RIVERBEND CROSSING
FILING NO. 1
STREET, STORM, & STRIPING
CONSTRUCTION DRAWINGS

STREET IMPROVEMENT, STORM SEWER, AND SIGNAGE & STRIPING CONSTRUCTION DRAWINGS

PCD FILE #: SF-18-044

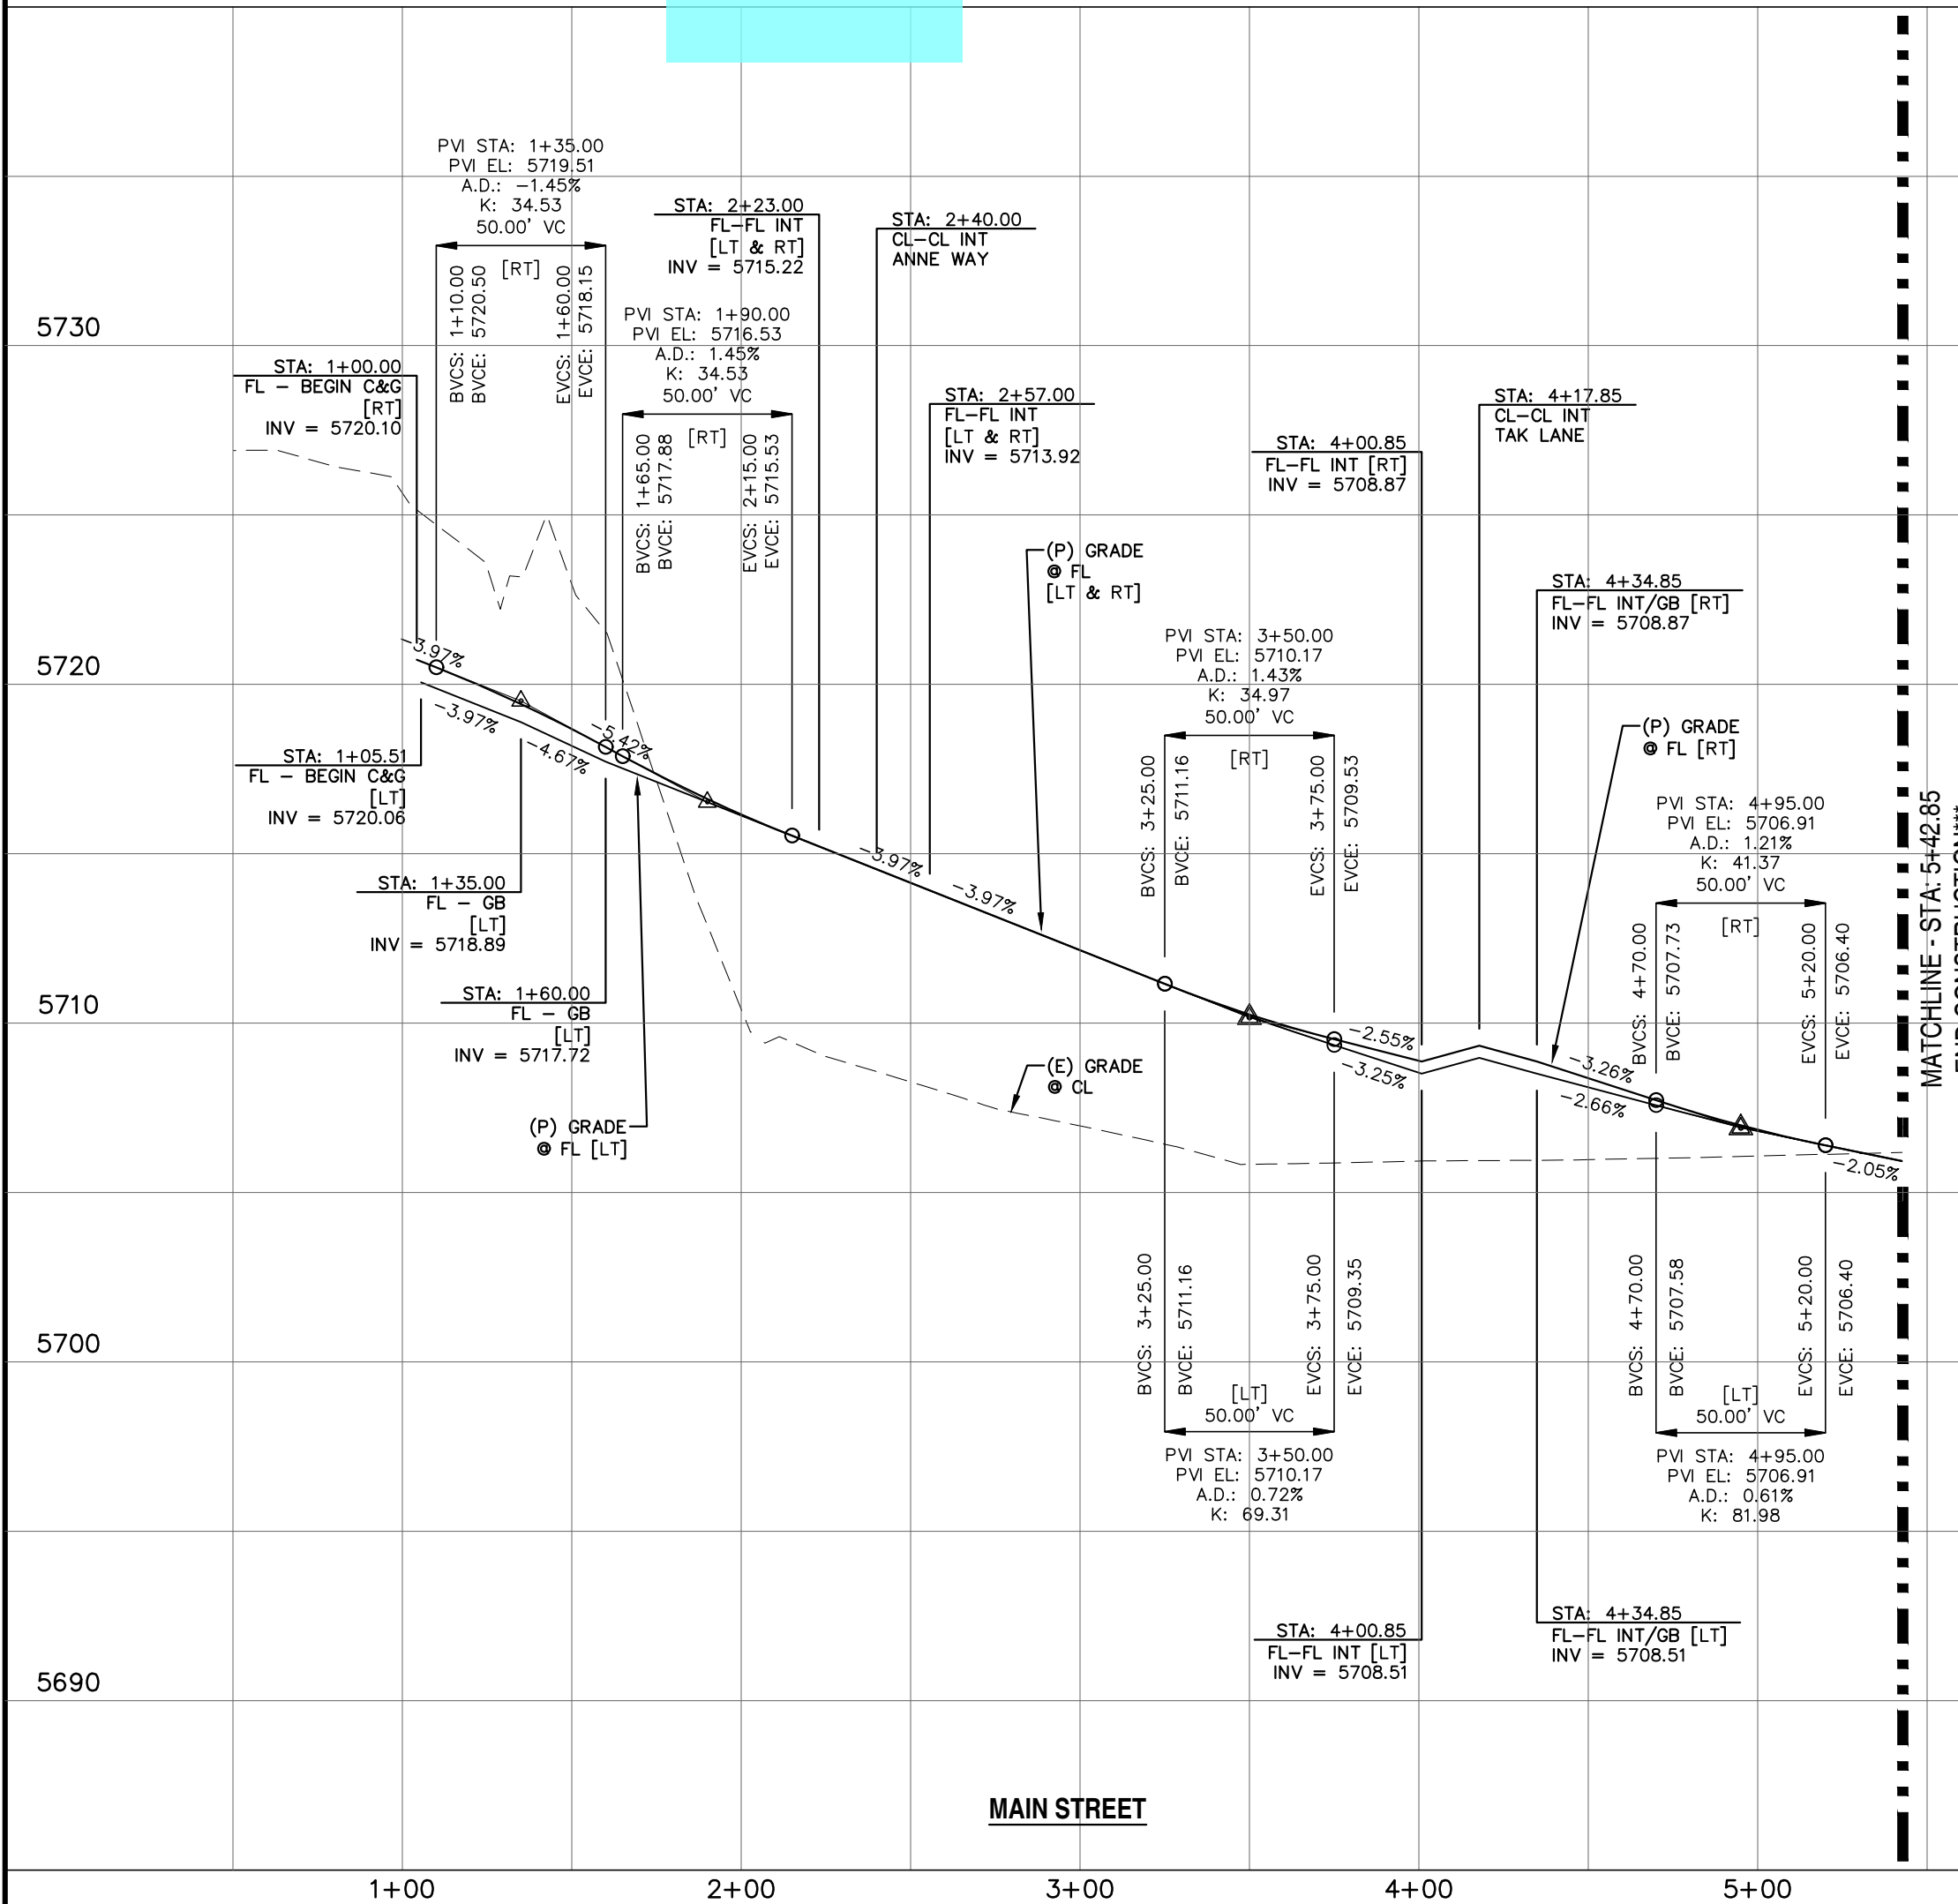
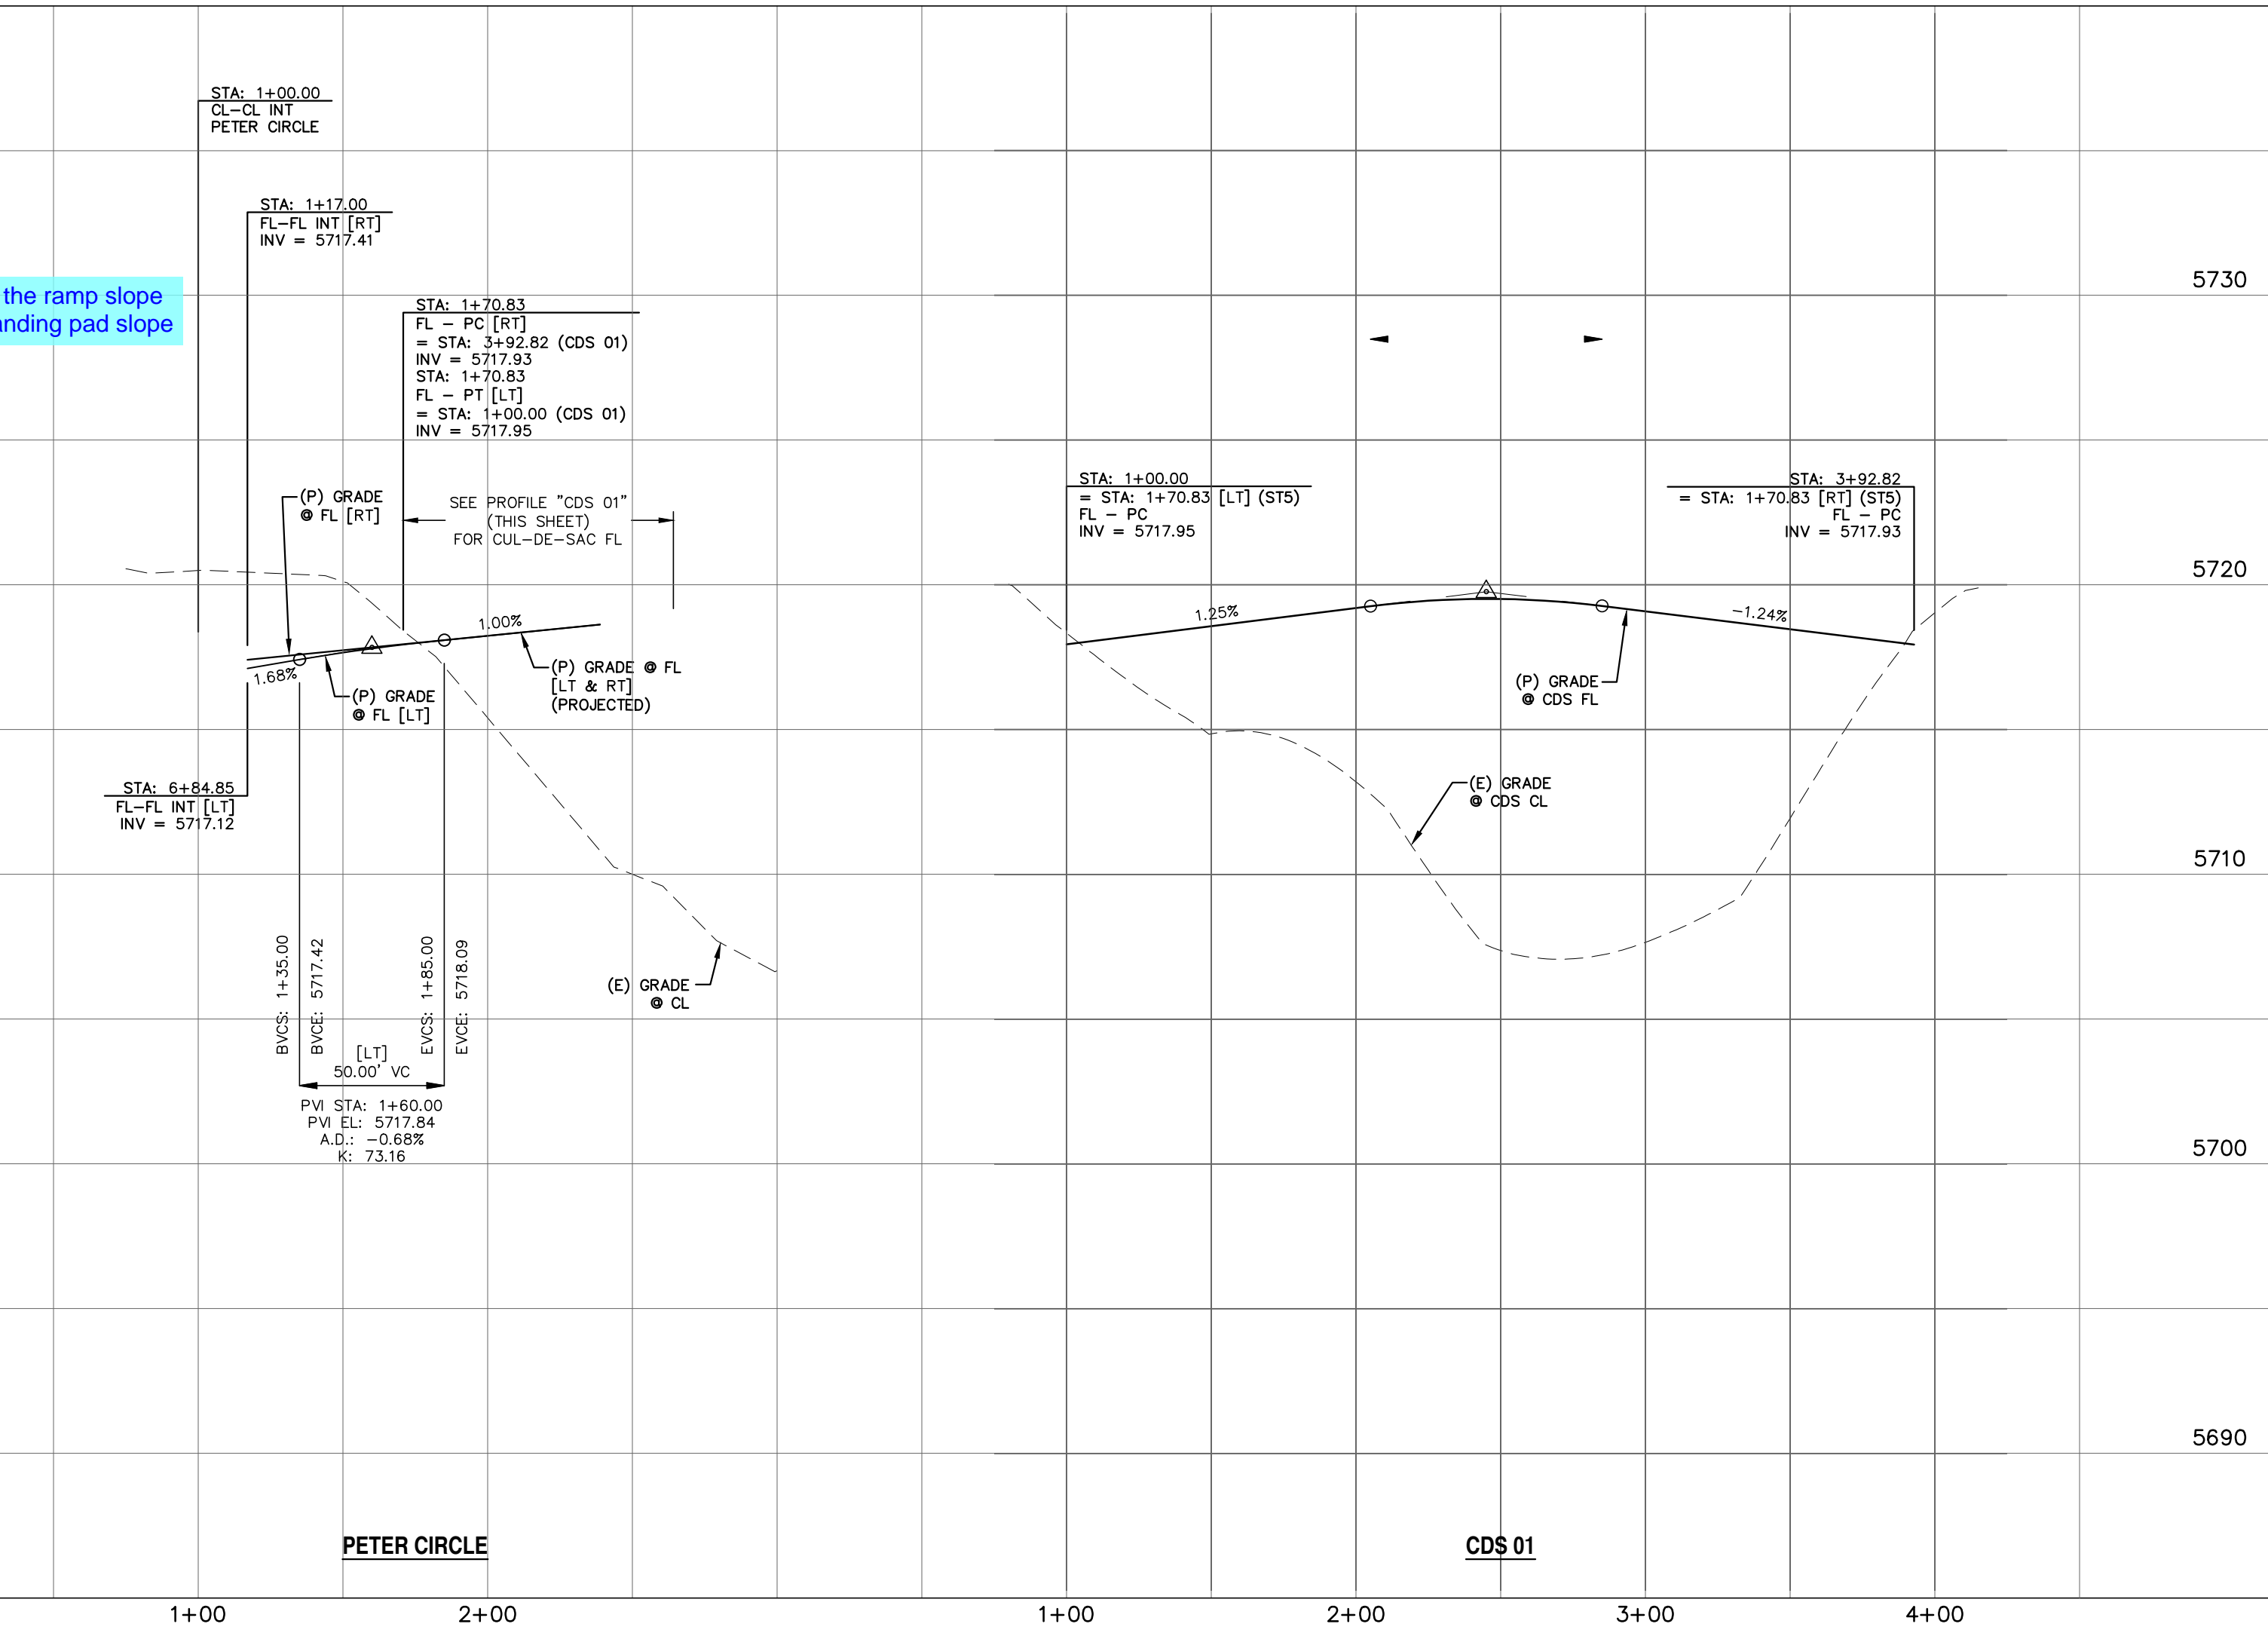
Show the cross slope of the pedestrian accessibility path on the paved road.

Label the ramp slope and landing pad slope

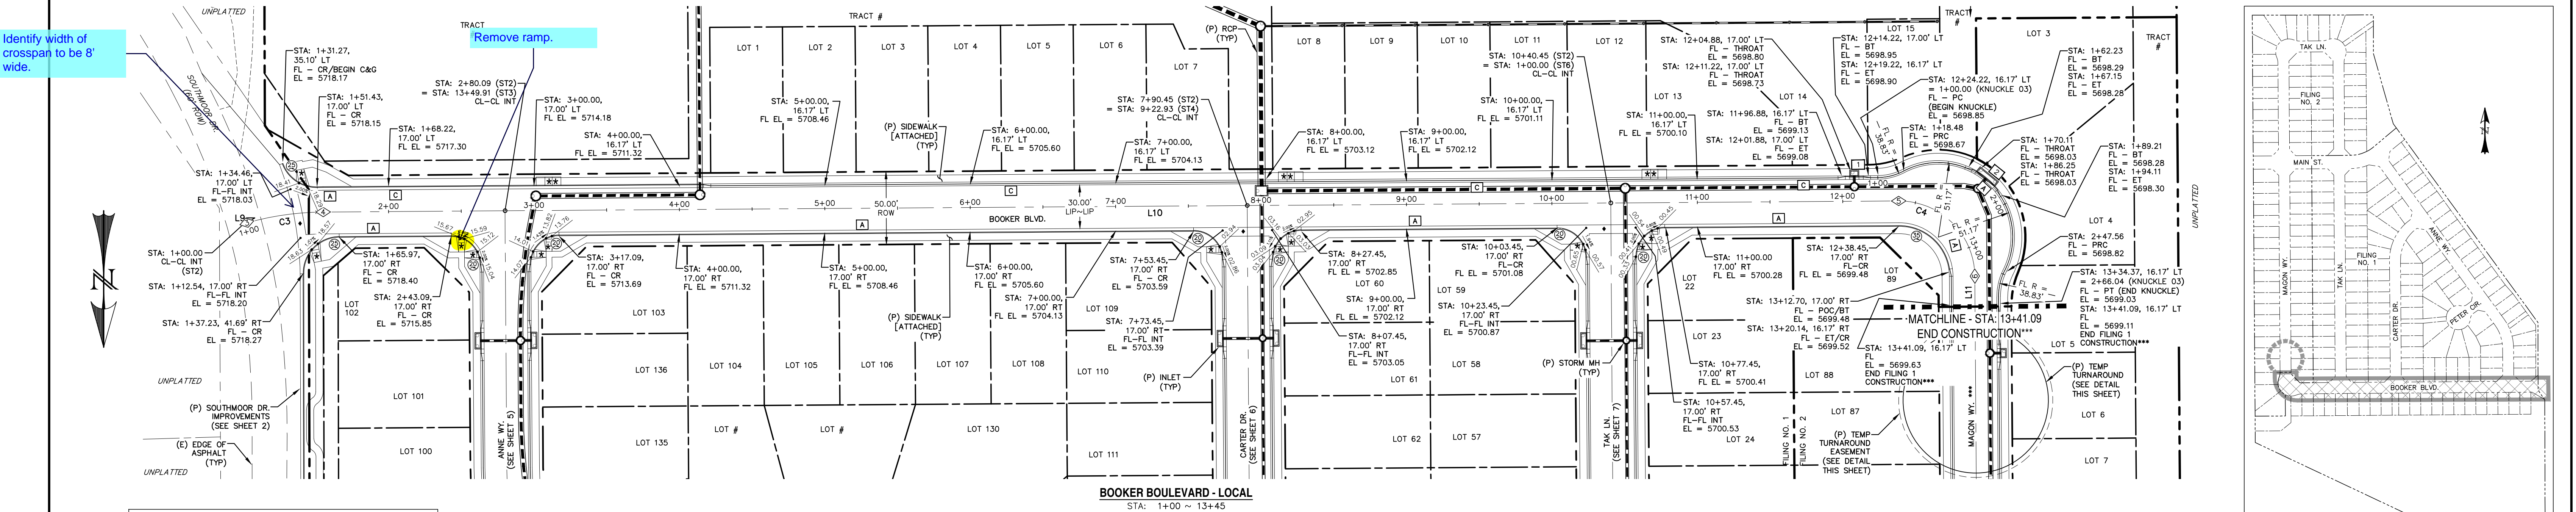
Identify width of crossspan to be 8' wide.

STM-03 [PVT & PUB]
STA: 2+50 ~ 12+50

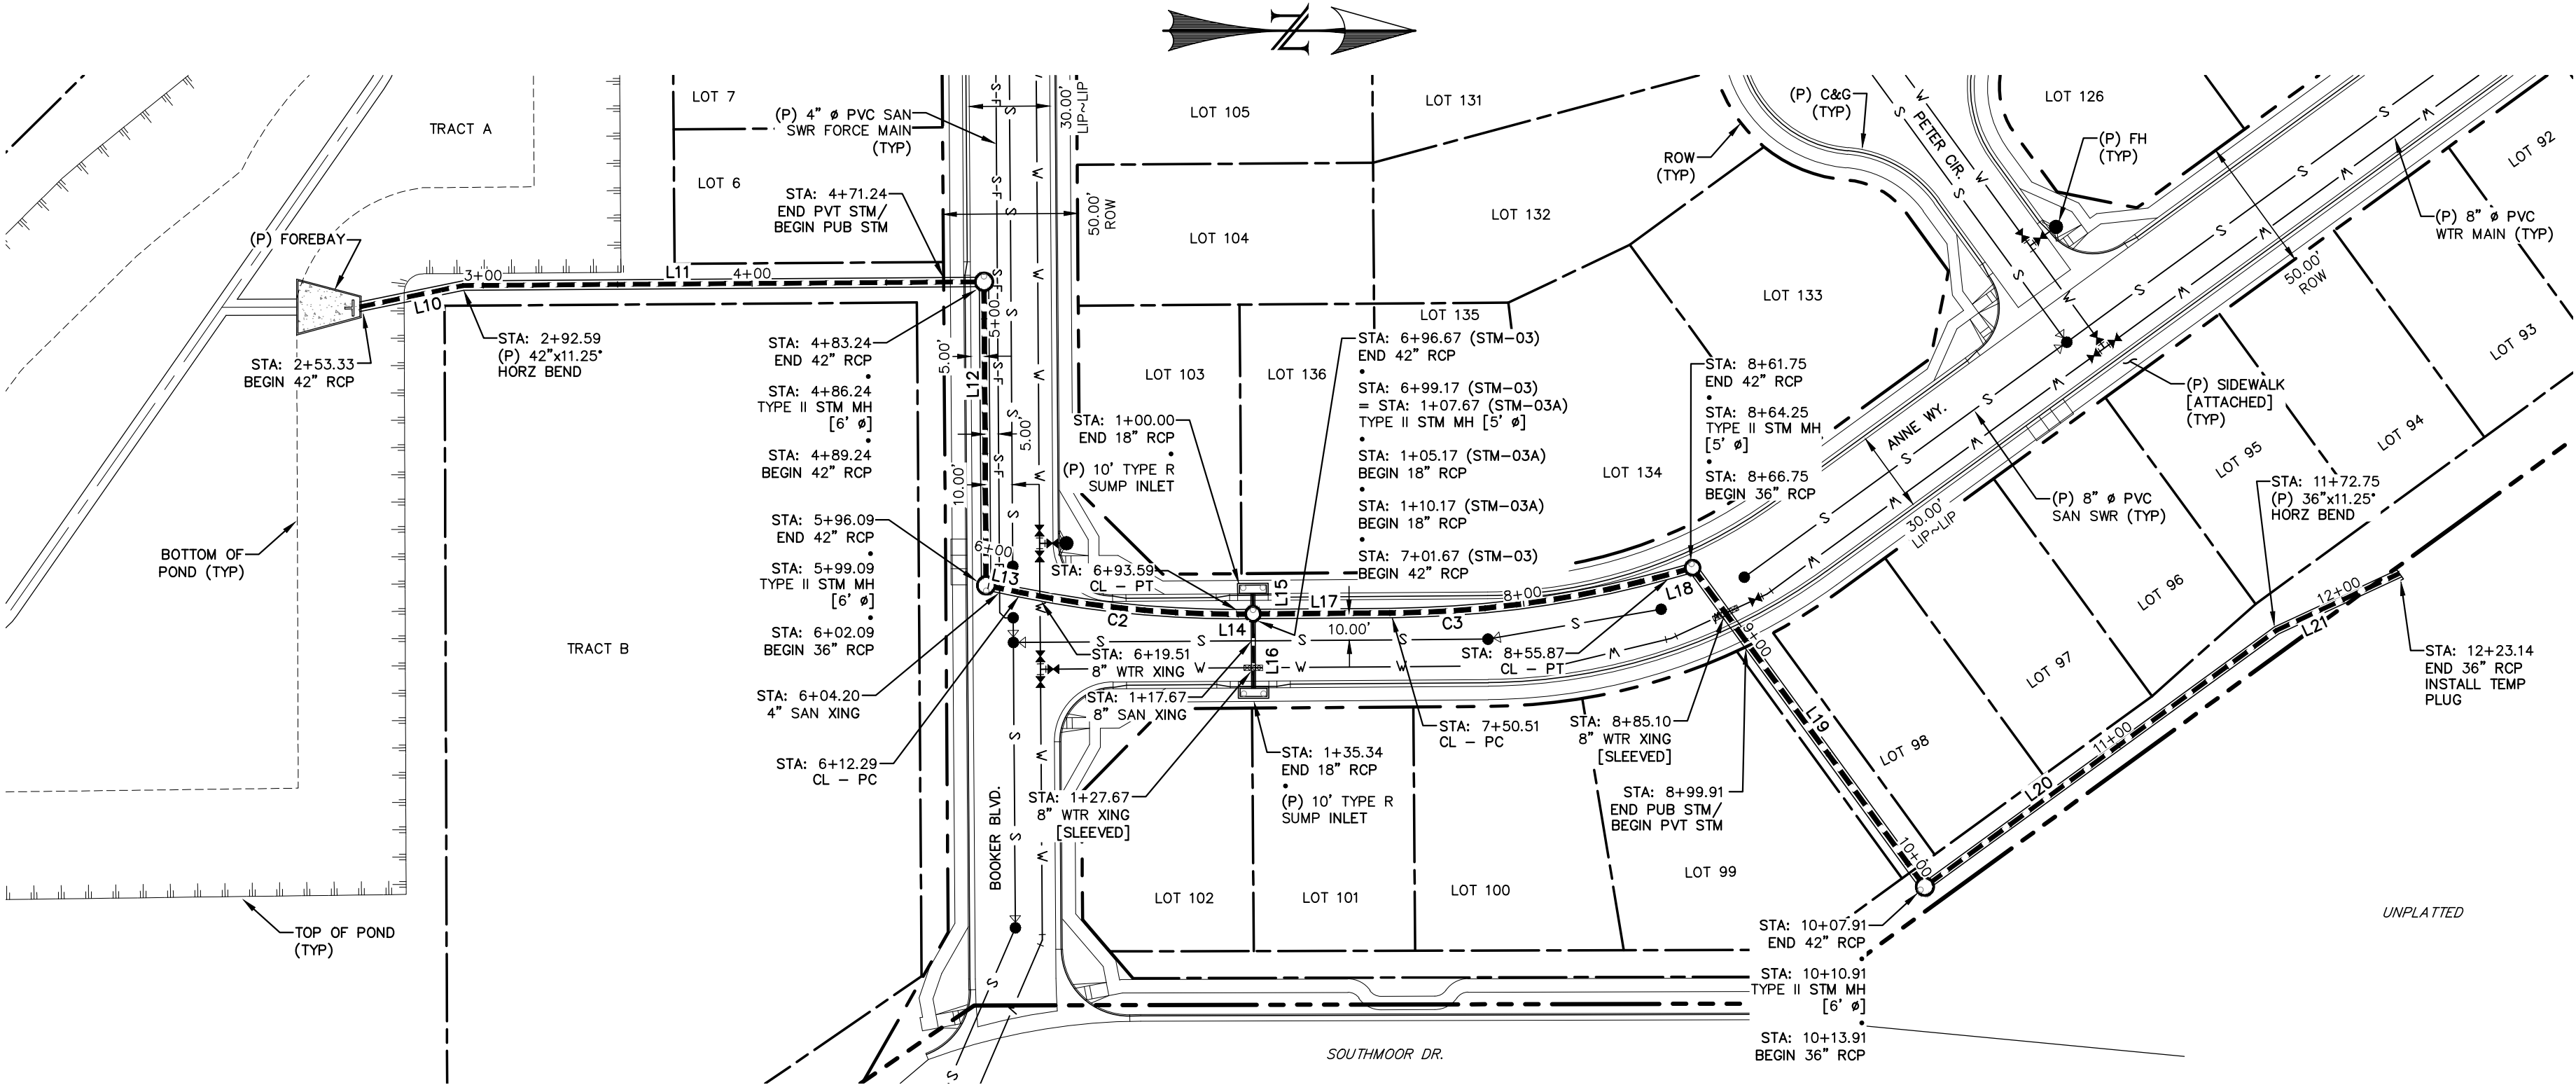
Revise to Type I SDMH
